Determination 2026/027

The compliance of a pool and associated pool deck with Building Code Clause F4 Safety from falling

152 Endsleigh Road, Havelock North

Figure 1: Plan view of pool, pool deck and access steps

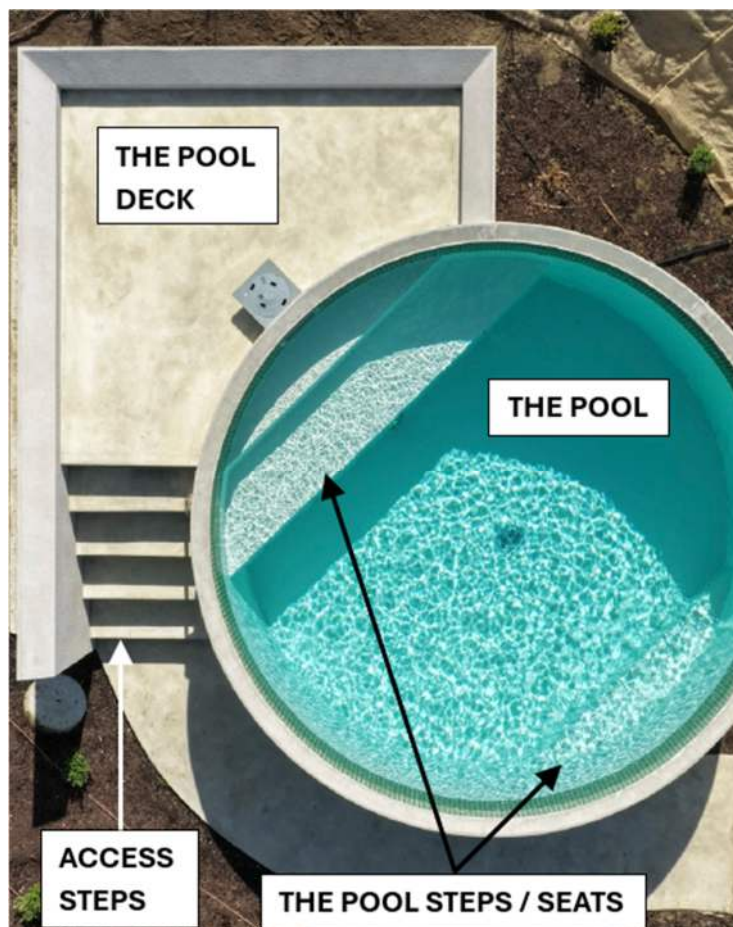
- 1.2.2. Hastings District Council (“the authority”), carrying out its duties as a territorial authority or building consent authority.
- 1.3. The matter to be determined, under section 177(1)(a), is whether a proposed pool and pool deck, as shown in figure 1, complies with Building Code Clause F4 *Safety from falling*. In deciding this matter, I will consider the likelihood people could fall one metre or more from a sudden change in level within or associated with the pool and pool deck.

- 2.3. The pool incorporates several internal steps / seats, as can be seen in figure 1. The two closest to the pool deck are 450mm and 750mm from the top edge of the pool; the step on the opposite side is approximately 40mm high above the pool floor. At their widest they provide enough space to sit or stand, but not at the ends where they meet the curvature of the pool wall.
- 2.4. The pool is intended to be orientated so the two steps / seats are closest to the pool deck for the purpose of getting in and out of the pool.
- 2.5. The pool wall is 100mm thick. It incorporates a 30-degree bevel that slopes into the pool, leaving a 30, wide flat surface at the top (see figure 2).

- 2.6. The pool deck, constructed of reinforced concrete, is approximately 4m long and 3m wide. It is broadly L-shaped and adjoins onto one quadrant of the pool (see figure 1).

- 3.3. The authority considers that a fall exceeding 1m could occur from the pool wall, which is "reasonably wide and level". Users may access the pool edge from the pool or the deck area, and a person could also fall from a floatation device. The authority believes the edge geometry of the pool does not adequately restrict access or reduce the risk of a fall for the purposes of clause F4.
- 3.4. The authority also considered the design of the pool deck wall incorporates a perimeter edge where a fall of 1m or greater as it "is reasonably wide and level". This detail is not considered comparable to Figure 6 of Acceptable Solution F4/AS1³ in an "area intended or likely for pedestrian use".
- 3.5. The proposed "design does not demonstrate compliance with...clauses 4.1 and F4.3.1".

- 4.13. Based on the proposed design of the top edges of the pool and pool deck wall, I conclude people are not likely to be in a position where accidental fall of one metre or more is likely, and therefore the pool and pool deck complies with clause F4. I note this conclusion is reached on the basis of the information provided to me about the height and dimensions of the pool and deck wall, and the same conclusion may not be reached in other circumstances where those differ.

- 5.1. In accordance with section 188 of the Building Act 2004, I determine the proposed design of the pool and pool deck as described in this determination complies with clause F4 *Safety from falling*.

Figure 2: The pool edge (not to scale)

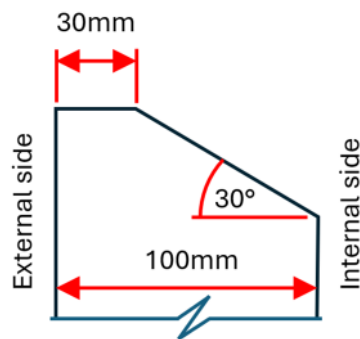
- 2.8. The wall that surrounds the pool deck is to be 1.2m high above the finished ground level. Based on the owners’ submission on the height of the pool deck, this would make the surface of the pool deck more than 200mm below the top of the wall that surrounds it.² The wall is approximately 190mm wide and, similar to the pool wall, the top incorporates a 30-degree internal bevel, leaving a 32mm wide flat top.

- 3.1. The owner's position is that while the vertical height from the top of the pool edge to ground level exceeds 1m, the pool wall does not function as a location from which a person could fall, and functions instead "as a non-walkable boundary rather than a platform". This is because:

- 3.1.1. the geometry of the top of the proposed pool wall does not constitute an occupiable or useable surface, and the design discourages sitting, standing or pedestrian use.

- 4.11. Considering the proposed design, incorporating an approximate 30 to 32mm wide top edge and 30-degree internal bevel, I am of the view:
- 4.11.1. The size of the flat surface and the 30-degree internal bevel mean it is less likely persons would be on the top edges of the pool and pool deck wall and therefore would not require protection from the likelihood of accidental fall.

- 4.11.2. Although a person inside the pool could grasp the top edge of the pool to lift themselves up, falling over the wall would require deliberate effort to shift their body mass over the edge, making an accidental fall in normal use unlikely.
